August 11, 2023

**RE: Planned Development Application Ryan Field – 1501 Central Street
Response to July 31, 2023 Staff Review Letter**

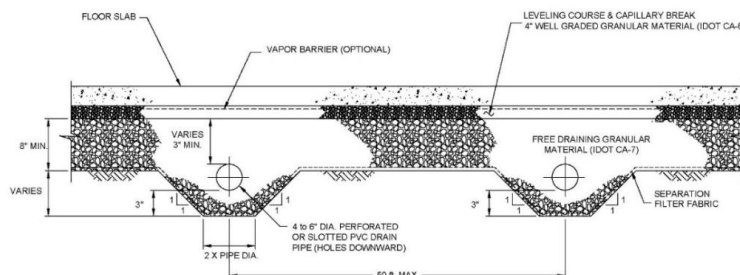
C. Open parking area near Central Street with a 6 ft. 10 in. setback where 15 ft. is required.

RESPONSE: Acknowledged. However, please note the following:

- *The closest point of encroachment to the north-south property line is 4 ft to the face of curb of the proposed driveway. The length of the encroachment is 165 ft.*
- *The closest point of encroachment to the east-west property line is 6.8 ft. to the face of curb of the proposed parking lot drive aisle. The length of the encroachment is 68 ft.*
- *Dimensions have been added to DP-02 to clarify these two encroachments.*
